Orchards at Grand Teton & Teton - units 2 & 3

PROJECT: (update to DS 4558 & DS 4274)

SUBMITTAL: 2nd

CITY OF LAS VEGAS		DATE:
INTER-OFFICE MEMORANDUM		October 18, 2012
TO: Land Development Services Department of Public Works		FROM: Albert Sung, P.E. Flood Control Project Engineer Department of Public Works
SUBJECT: Drainage Study for: Orchards at Grand Teton & Tenaya – Units 2 & 3 (Update to DS4558 & DS4274)		COPIES TO: Taney Engineering
Cross Streets:	SWC of Grand Teton Blvd. & Tenaya Way	D.R. Horton
File Number:	F:\Depot\DSMemos\DS4569B.doc	Bart Anderson, P.E., DevCo
Parcel Number:	125-15-101-003	CCRFC
Zoning Action:	TMP-45536	CCPW
FEMA Flood Zone	YES	NO X
Proposed Storm Drain	YES	NO X

GRAND TETON - PLAN
STA: 8+00 TO 17+50

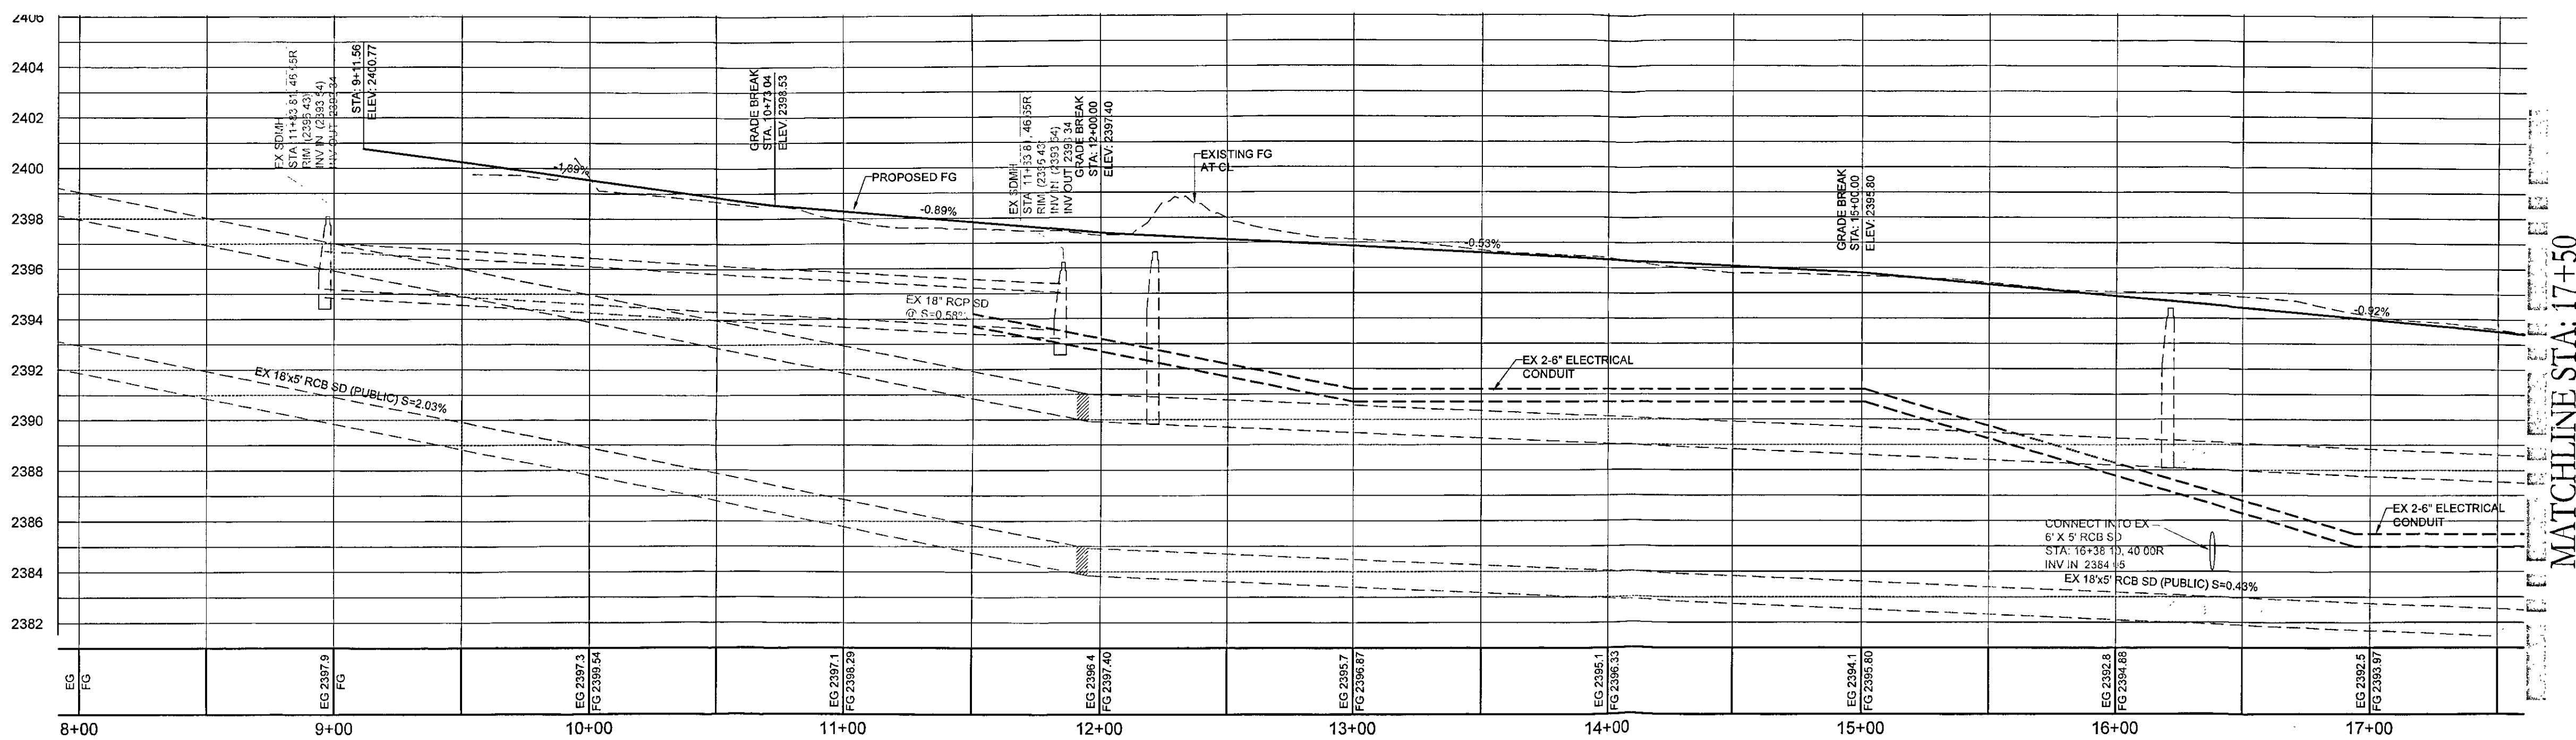
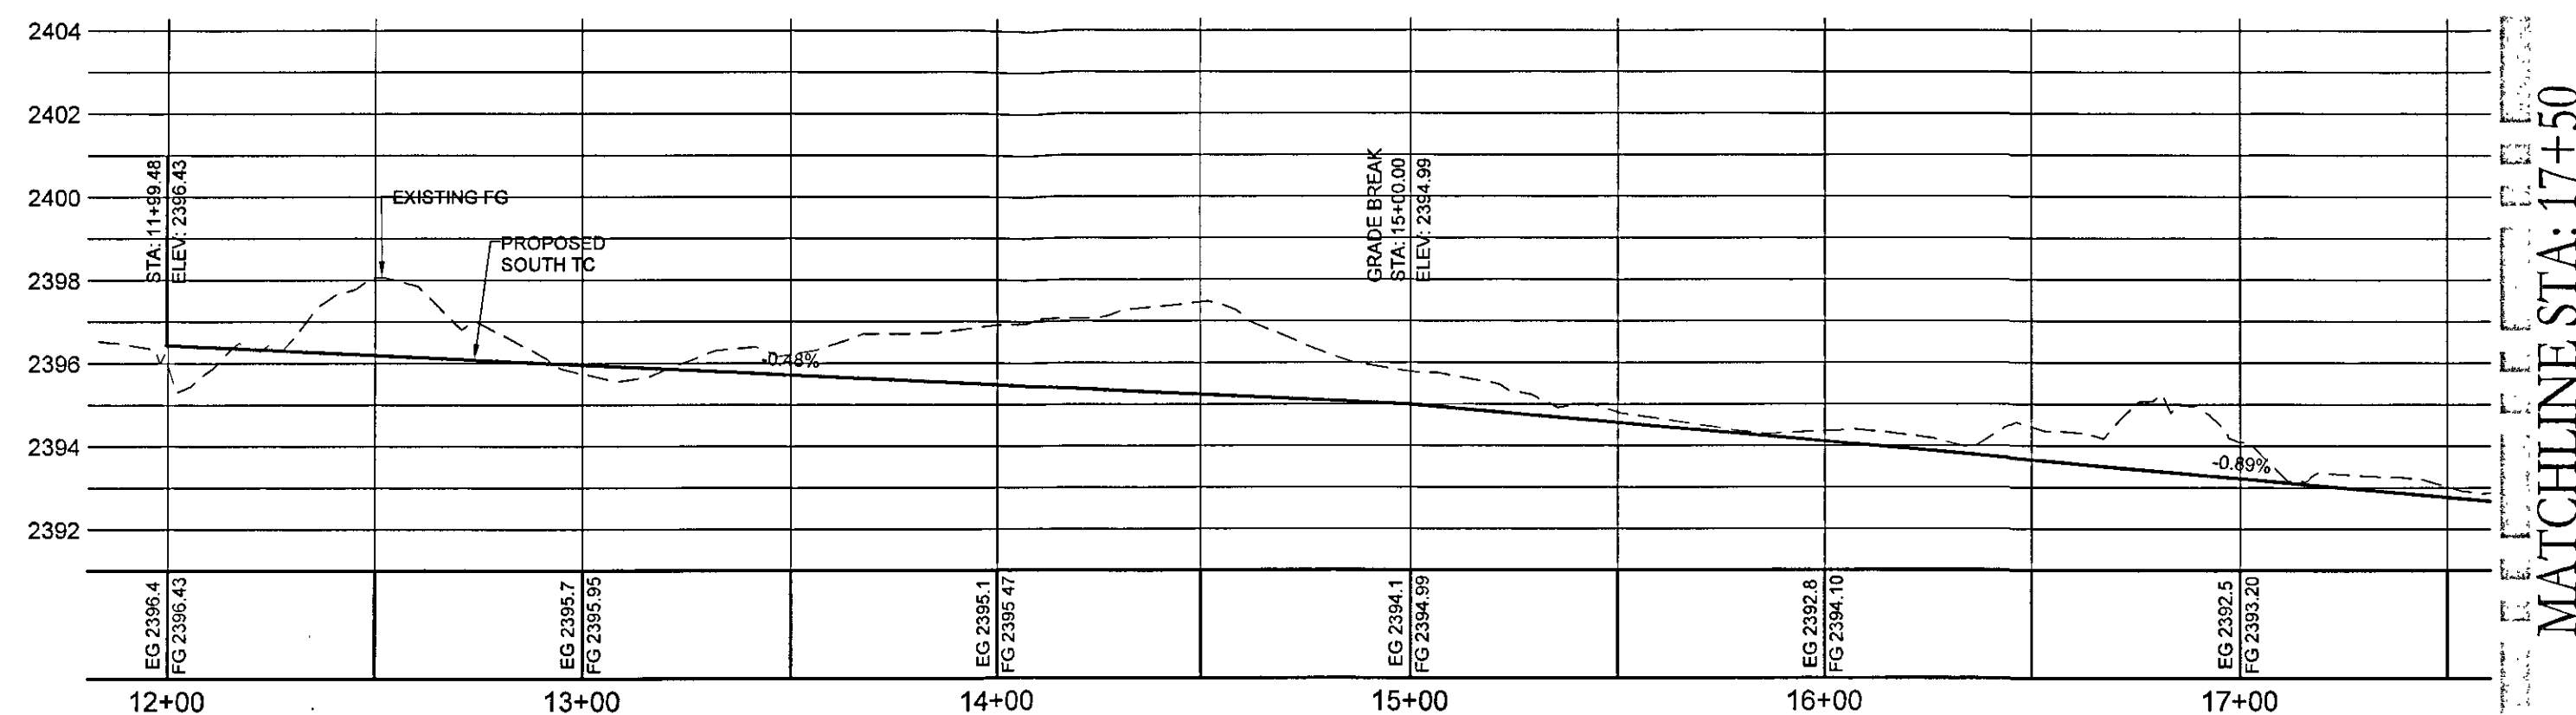
1. The proposed onsite channel along *Grand Teton Boulevard* has a trapezoidal section which in comparison would have a lesser conveyance than a rectangular section if the top widths are the same. It appears that a rectangular channel would have a better effect to lower the water surface elevations in the street than the trapezoidal counterpart during a 100-year major event.

Run a HEC-RAS model with rectangular section channel and provide two tables for comparison of the water surface elevations.

3. The minimum required width of the drainage easement containing the channel is 20'. Revise all pertinent plans and details accordingly.
4. **Sheet G2:** Provide or extend a head wall at the end of the proposed channel to direct the outfall into *Grand Teton Boulevard*. Show hydraulic calculation to verify a freeboard of at least 12" is provided at the head wall.

5. Provide a guard rail along the north side of the channel for safety measure. Revise the grading plan and all pertinent details accordingly.
6. Revise all proposed 4'-Type C drop inlets to Mod. Type CM with L = 5'.

TENAYA WAY STA:15+00 TO 24+00

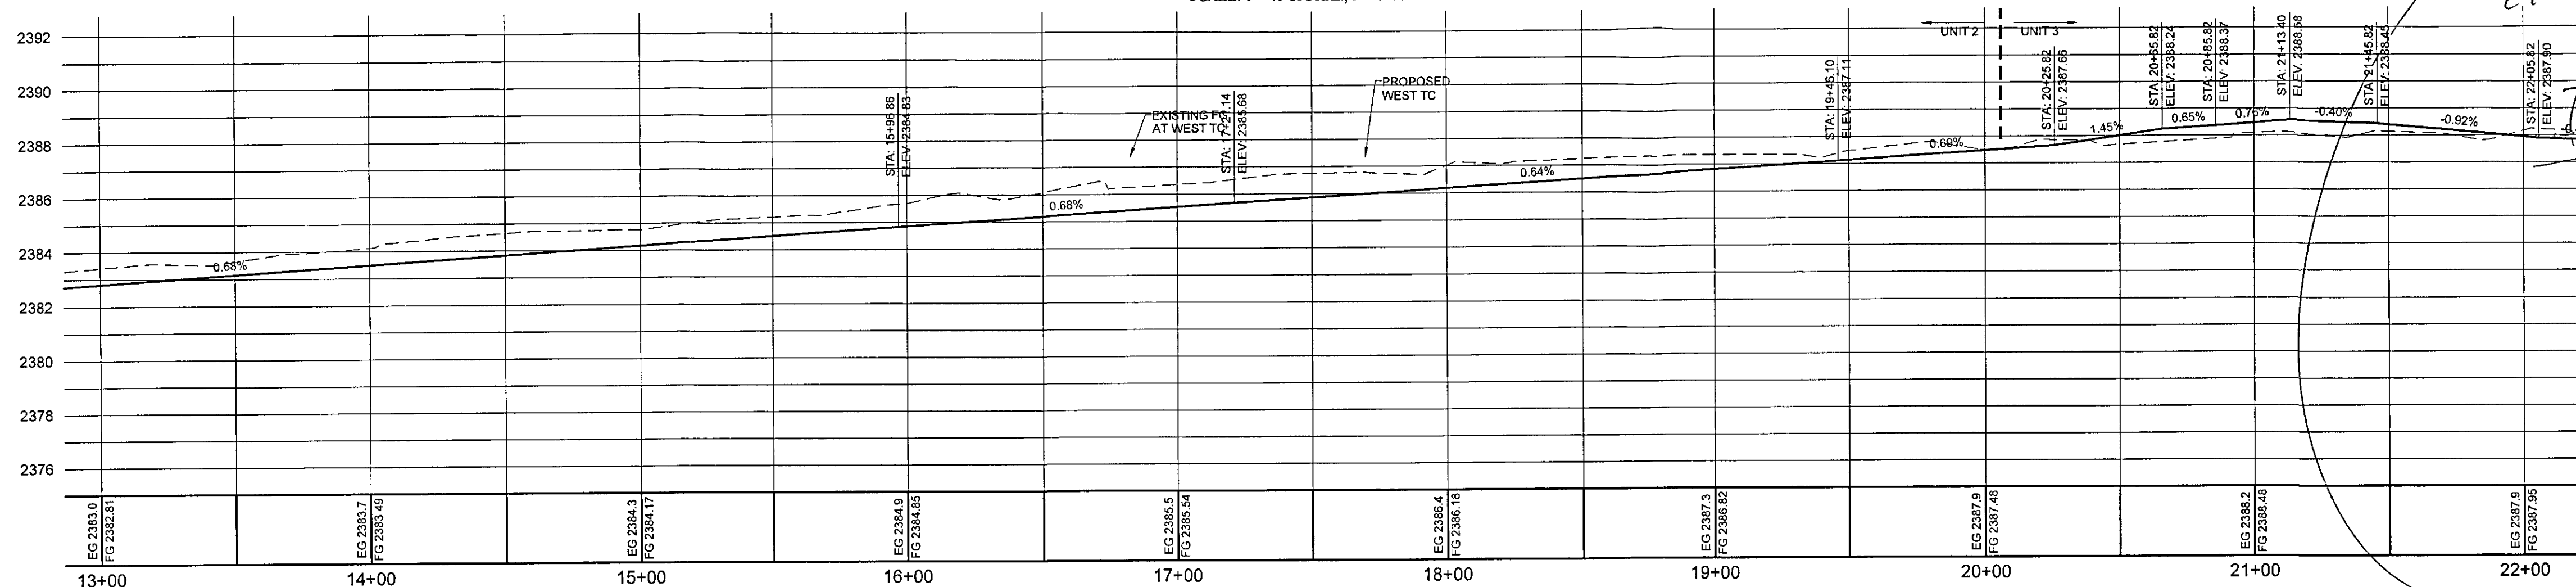
8. **Sheet PP4:** The plan and profile of *Tenaya Way* is still shown as proposed (ie, solid lines). Review and revise accordingly.
